TT229 – January 23, 2006

### 2006 FLHTCUSE “CVO” Heated Seat

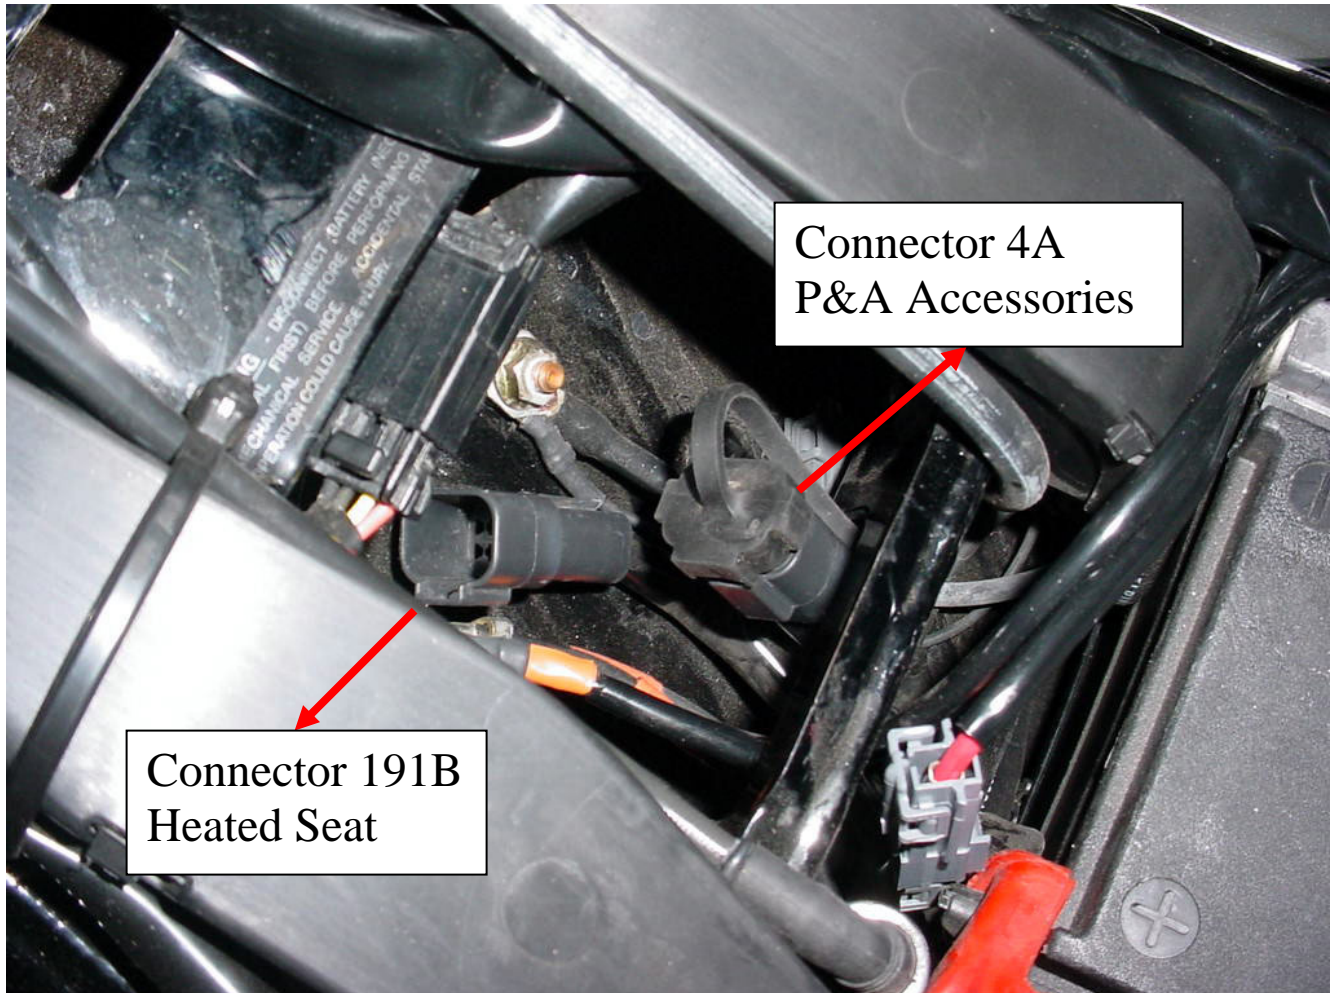
The seat on the 2006 FLHTCUSE is plugged into connector #191B; this connector is located near the accessory connector #4A which has a rubber plug in the connector. Make sure the seat is plugged into the correct connector, if it is not you would need to turn on the accessory switch to operate the seat. The picture below shows the 2 connectors.
